Case # 13-15

FROM: Warren White, City of Chandler Representative

SUBJECT: Proposed Revisions to MAG Sections 601, 603, 615, 618, 735, 101 and Dtl 200

Proposed Trench Excavation Definitions for MAG Section 101

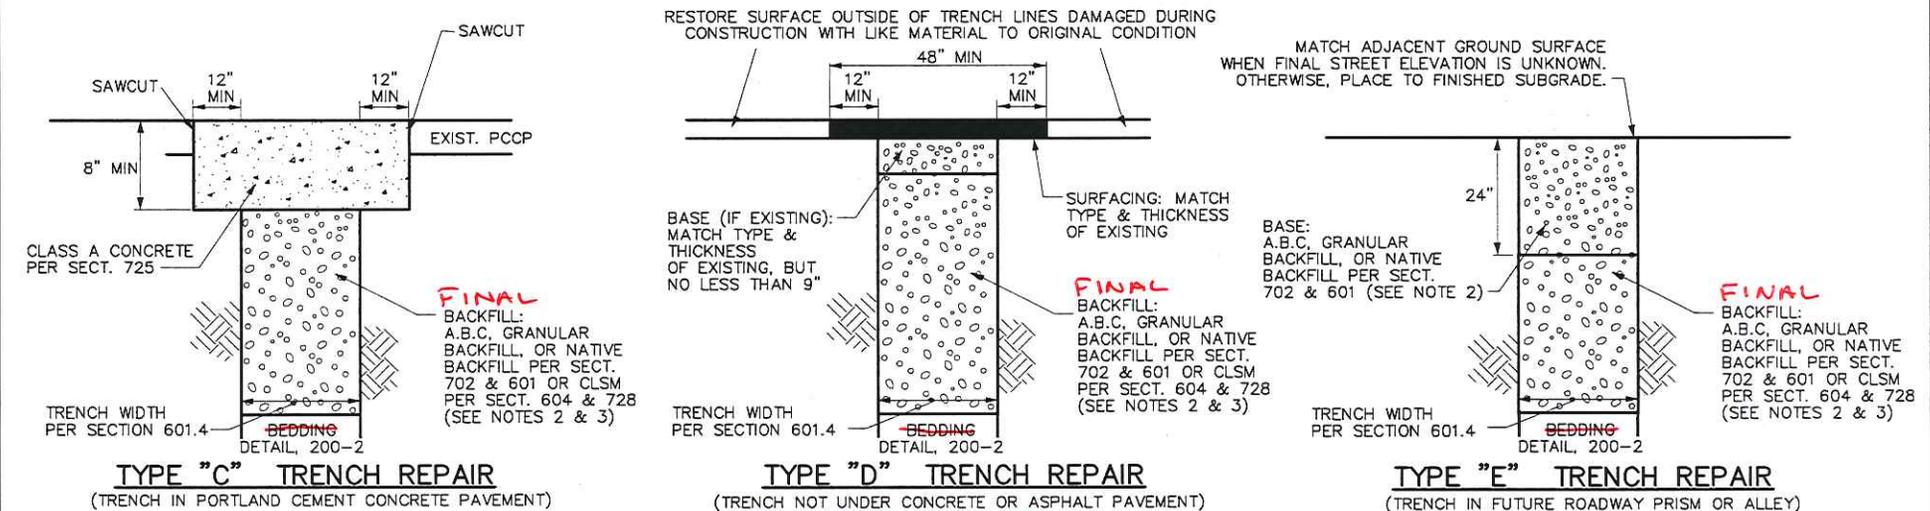
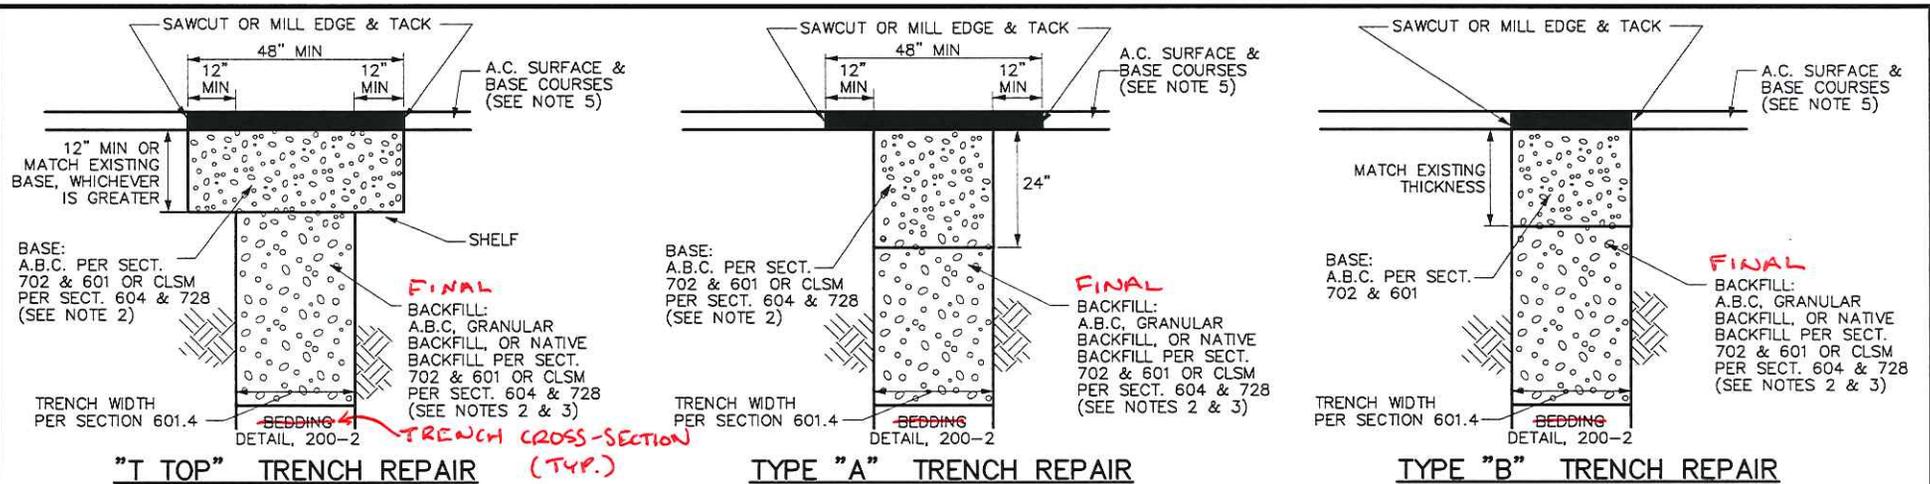
Haunching – The area of a pipe trench backfill envelope that provides the majority of resistance against soil and traffic loadings. The haunching area is defined as the zone between the bottom of the pipe and the centerline, or springline, of the pipe.

Springline – The horizontal centerline of a pipe in a pipe trench backfill envelope. The springline separates the haunching area from the initial backfill in the pipe embedment zone.

Bedding - (current MAG definition: Is the material placed in the area from the bottom of the trench to 1 foot above the top of the pipe or conduit.) *New definition proposed:* A backfill material layer placed on top of the pipe foundation to the bottom of the pipe, typically 4 – 6 inches in height. The bedding establishes line and grade to provide firm, but not hard, pipe support.

Foundation – (current MAG definition: For buildings or structures, this will be the substructure. For pipe this will be the native material or prepared material on which the pipe rests: normally, this is the bottom grade line of the trench). *New definition proposed:* For a pipe trench the foundation is defined as the native or prepared material upon which the bedding material is placed.

Initial backfill – The area of a pipe trench backfill envelope defined as the area between the springline and a minimum of 12 inches above the crown of the pipe.

Final backfill - The area of a pipe trench backfill envelope defined as the area above initial backfill to the top of the trench or to the bottom of the road base material. Final backfill is typically compacted native material.

Pipe embedment zone - The area of a pipe trench backfill envelope, consisting of the bedding, haunching, and initial backfill areas.

DETAIL NO.
200-2

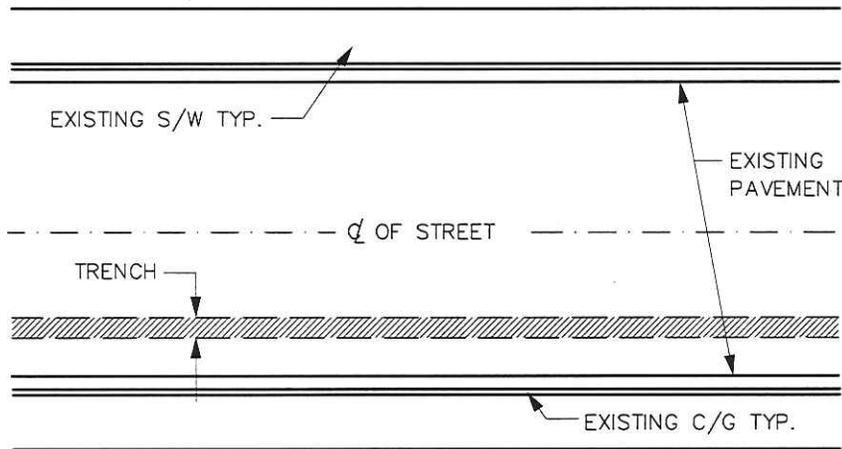
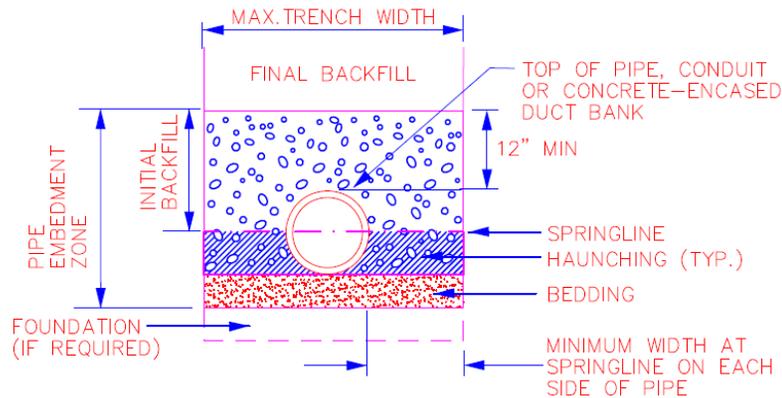
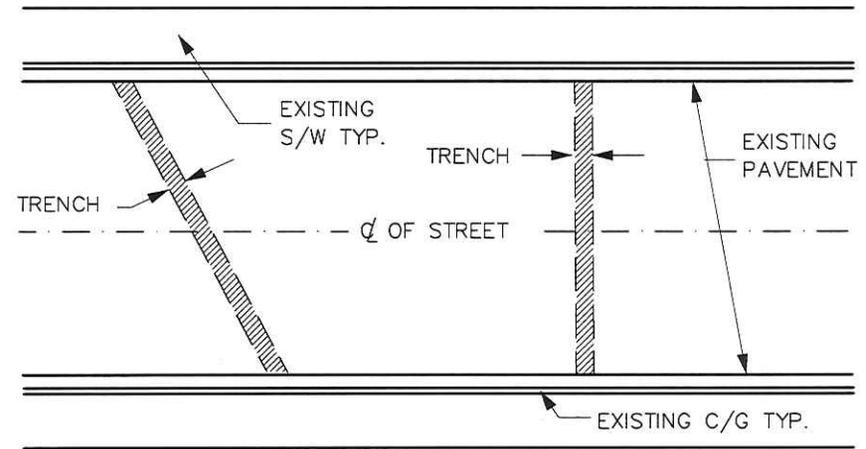
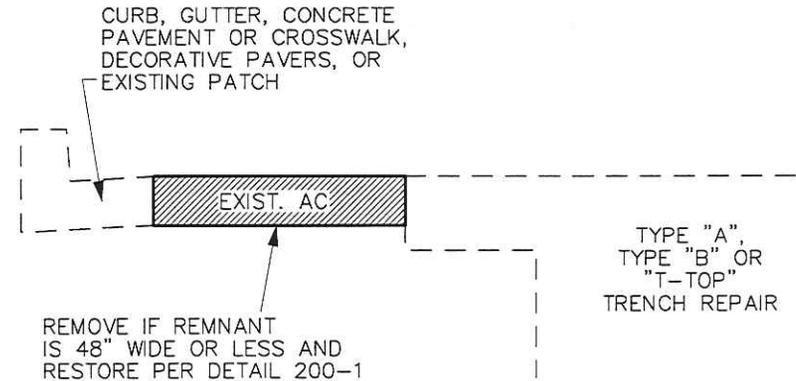
- 2) Revise Section 601, Trench Excavation, Backfilling and Compaction, to be specific to rigid pipe.
- 3) Revise the Bedding Detail on Detail 200-2, to match ASTM terminology. Graphical changes to clarify new defined areas. Also, revisions to Detail 200-1 for consistent terminology.

- TRENCHES LESS THAN 24" WIDE SHALL BE BACKFILLED FROM TOP OF BEDDING TO BOTTOM OF SURFACING MATERIALS WITH 1/2-SACK CLSM PER SECTIONS 604 AND 728.
 - ~~BASE, BACKFILL, BEDDING AND FOUNDATION~~ COMPACTION REQUIREMENTS SHALL BE IN ACCORDANCE WITH SECTION 601.

1. SEE SECTION 601 FOR RIGID PIPE INSTALLATION AND 603 FOR FLEXIBLE PIPE INSTALLATION.
2. SEE MAG DETAIL 200-1 FOR DETAILED TRENCH REPAIR REQUIREMENTS FOR TRENCH TYPES NOTED HEREIN.
3. SEE MAG DETAIL 211 FOR REQUIREMENTS REGARDING THE USE OF PLATING TRANSVERSE TRENCHES. USE OF STEEL PLATES SHALL NOT EXCEED 72 HOURS AFTER COMPLETION OF BACKFILL AND PRIOR TO FINAL PATCHING.
